RAJASTHAN STATE MINES & MINERALS LIMITED

CORRIGENDUM NO. 2

Sub : Consultancy Services for Design, Survey, Detailed Project Report Preparation, Tender Document Preparation and supervision for creation of additional pondage capacity by raising dam height utilizing inside material of Existing Tailing Dam located near Base Camp at Jhamarkotra Mines, Distt.- Udaipur

Ref. : e- Tender No. RSM/CO/Proj/TD/2018-19/22 dated 12.04.2018

General Layout Plan
of
Old Tailing Dam

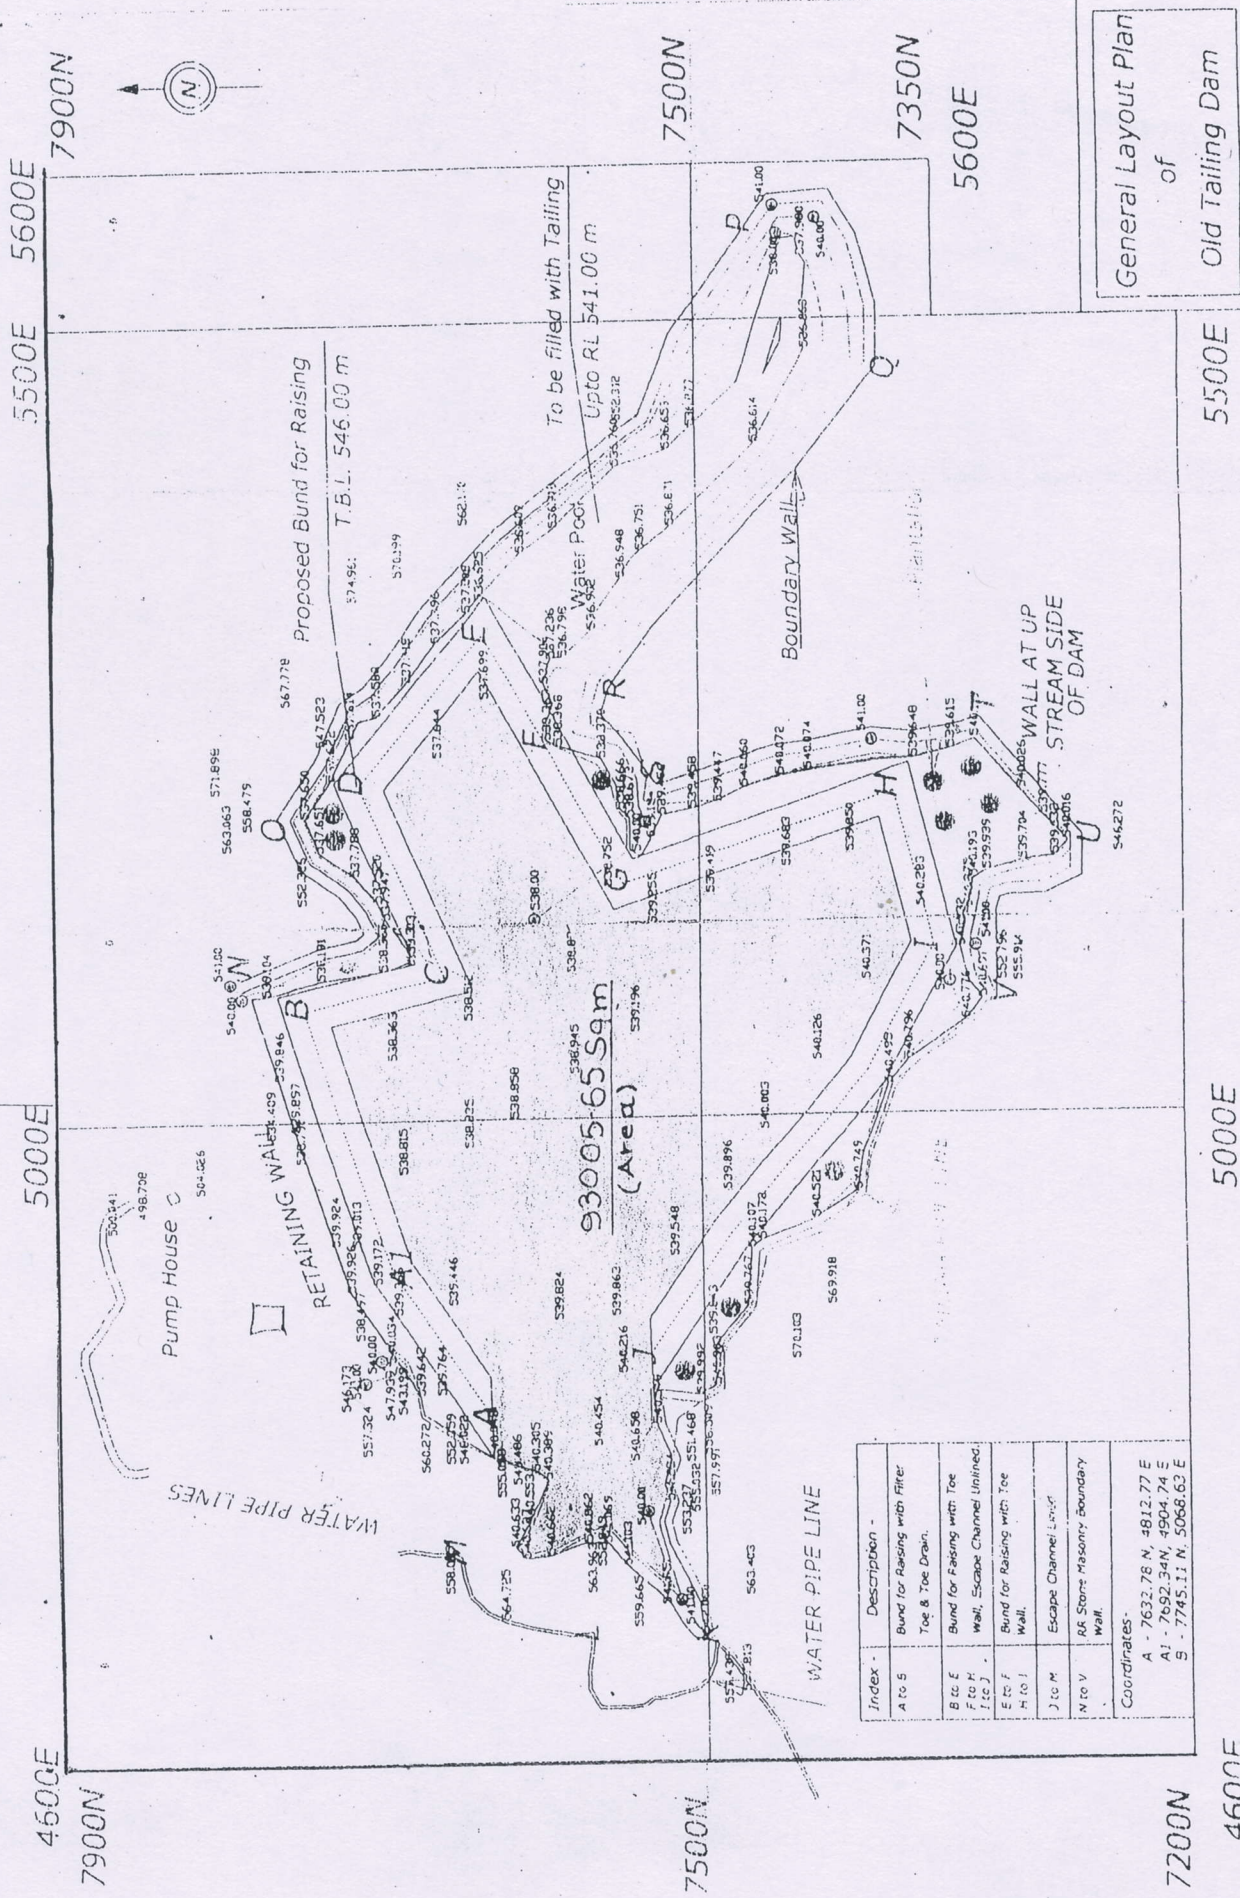
4	Section II, of tender document	Clause named Site conditions in Section II is added as: 1) <i>“The available decantation arrangement is working satisfactorily, however, rest of the exercise about structural and hydraulic design etc. are to be worked out by the consultant himself.”</i>
5	New Clause no.4.4 of tender document	Following is added in the clause as: <i>“Details of Tailing/Slurry are as under:</i> 1) <i>Maximum tailing produce is 1800 MT per day & Average tailing produce is 1200 MT per day.</i> 2) <i>Density of tailings slurry is 1.3 kg/litre (average).</i> 3) <i>Number of production days per year is 300 days (average).</i>

4) <i>Tailing deposit is classified as soil, refer Annexure –X. the prospective bidder may also collect the sample from Jhamarkotra site and get it tested for his purpose.</i>
6	New definition named Waste rock stability buttress in Section-I, of tender document	Following definition is added in the clause as: 1) <i>“Waste rock stability buttress means (A low cost ‘toe filter’ like structure made up of waste rock either generated from mining activities or from excavation activities at site provided at downstream toe of earthen dyke also providing stability against lateral displacement.)”</i>
7	DNIT of tender document	Following is added in DNIT of tender as: 1) <i>“Joint ventures/consortium/ partnership are allowed to participate in this tender subject to the joint/several responsibility, in such cases the cumulative turnover of partners/members will be considered.”</i>
8	New Clause no.9.28 of tender document	Following is added in the clause as: 1) <u>Regulatory and other approvals</u> <i>“RSMML would seek approval from the concerned regulatory authority,if required to do so.</i> <i>All the approvals at RSMML’s end will be forwarded to the consultant under the signature of GGM (Project) or his nominated person.”</i>
